**Response to Second Request for Additional Information – ANP-10281P
“U.S. EPR Digital Protection System” (TAC No. MD4977)**

Revised Figure 4-1

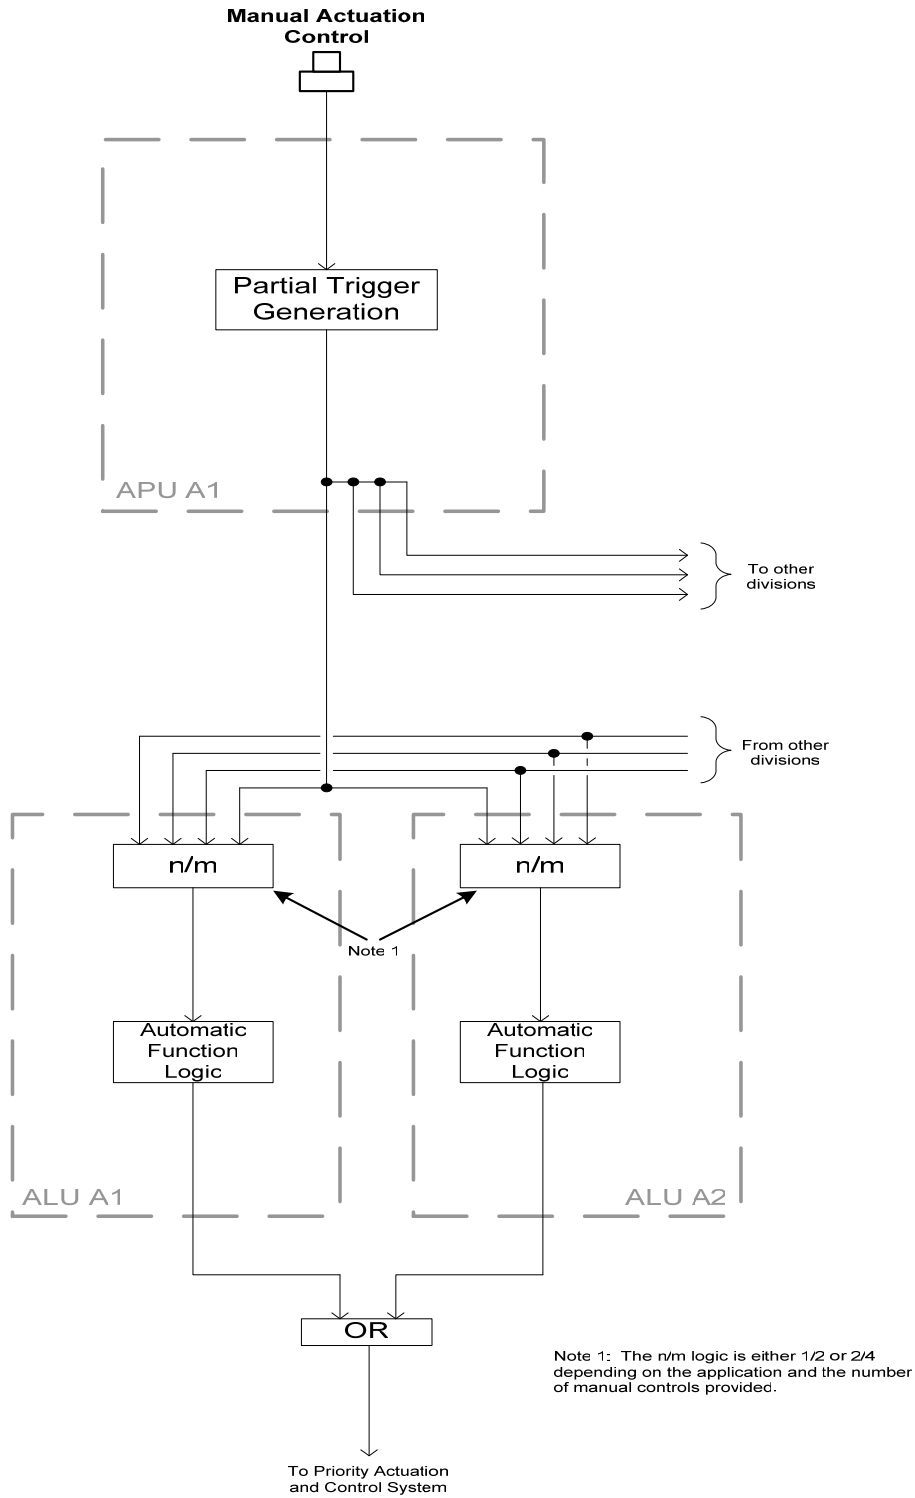
RAI 32: *Please clarify or correct the parenthetical bus numbering shown on the right side of Division 4 of Figure 4-1.*

Response 32:

The parenthetical bus numbering shown on the right side of Figure 4-1 is corrected in the attached revised figure 4-1.

Revised Figure 8-3: Typical #1 for Manual System Level Initiation

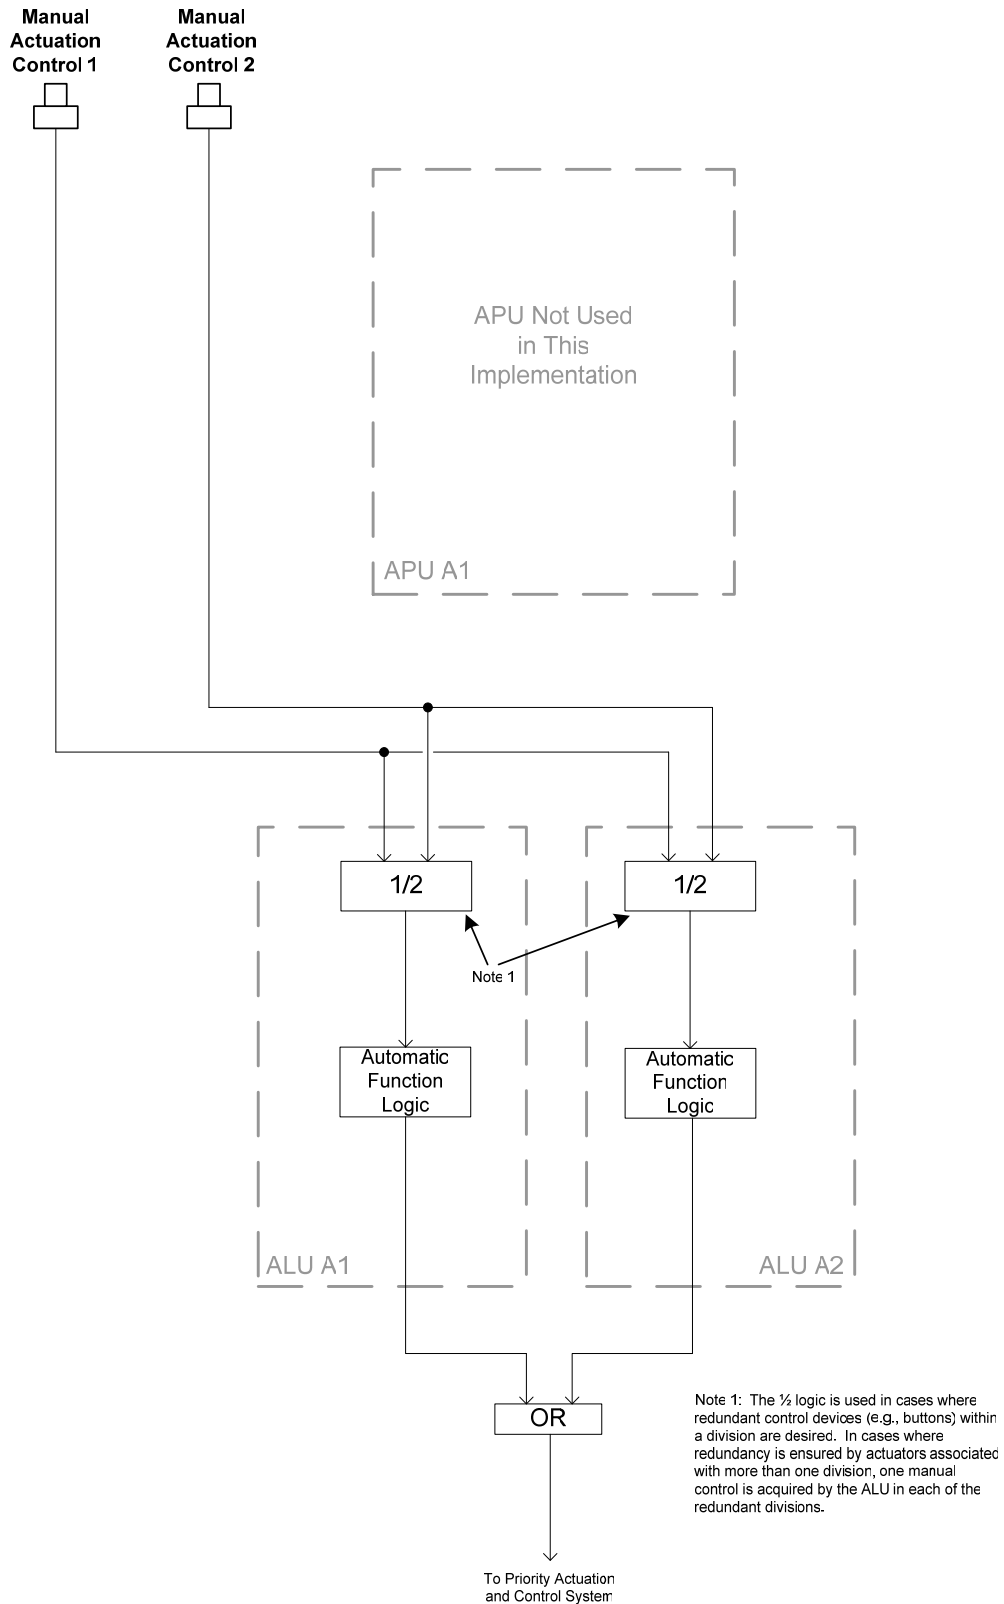
RAI 18: *Please describe when the implementation of each manual system level actuation of ESF functions will be determined.*

Section 8.5 says: "The implementation of manual system level actuation of ESF functions is determined on a case-by-case basis. ... Therefore, several typical implementation designs are identified and applied to the manual initiation functions to satisfy the requirements imposed on each individual function." It is not clear how this level of description cannot be considered conceptual. Please explain.

Figure 8-3 illustrates the implementation of a manual system level initiation function which utilizes both the APUs and ALUs of the PS. Redundant manual initiation controls in the MCR are acquired by APUs in different divisions of the PS. Each APU sends the status of a manual control to the ALUs in all 4 divisions. Voting is then performed in all divisions on the status of the redundant manual controls. This implementation is particularly suited to functions for which spurious actuation is of significant concern. It allows the manual initiation function to satisfy the single failure criteria, while taking advantage of ALU voting logic to significantly limit the probability of spurious actuation. In this implementation, independence is maintained between the redundant divisions of the PS in exactly the same manner as in an automatic ESF actuation function.

As a result of the above changes to Section 8.5, revised Figures 8-3, 8-4, and 8-5 have also been provided in this attachment.

RAI Figure 20-1

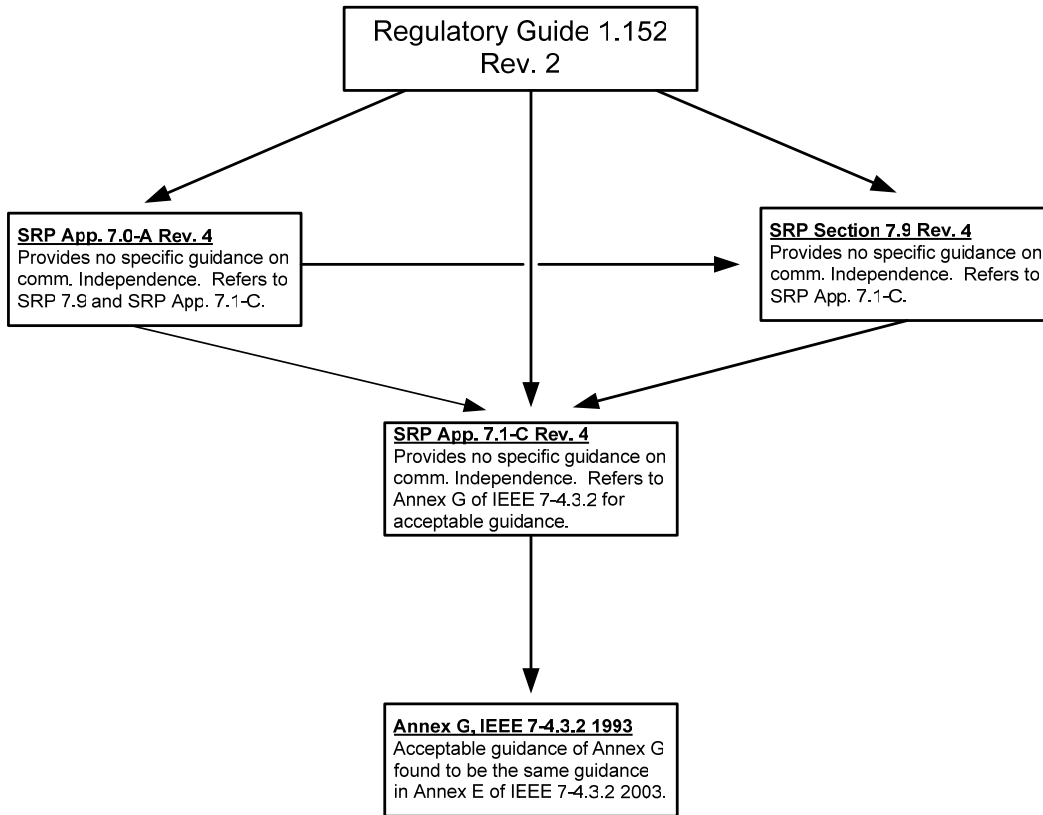
Section 12.2 says: “The TXS communication techniques provide communications independence between redundant divisions and are consistent with the guidance of Reference 14 [i.e. IEEE 7-4.3.2-2003 Annex E]. The related figure from Reference 14 is duplicated in Figure 12-2. An equivalent figure describing the TXS communication is shown in Figure 12-3. Figure 12-3 depicts the use of buffering circuits and separation of data flow (communication isolation), which provide an acceptable method of communication independence and prevents adverse interactions.” However, Section B of Regulatory Guide 1.152 Revision 2 says : ‘Annex E, “Communication Independence,” is not endorsed by the NRC because it provides insufficient guidance. Additional guidance is provided in Appendix 7.0-A, “Review Process for Digital Instrumentation and Control Systems,” Appendix 7.1-C, “Guidance for Evaluation of Conformance to IEEE Std 603,” and Section 7.9, “Data Communication Systems,” in NUREG-0800.’

Therefore, the answer to the RAI question of “acceptable to who?” ... is... “Acceptable to the NRC staff”; given that the communications independence annex of IEEE 7-4.3.2, and no other guidance on communications independence, was endorsed by the staff.

Figure RAI 20-1 illustrates the path of regulatory guidance that AREVA NP used to reach this conclusion.
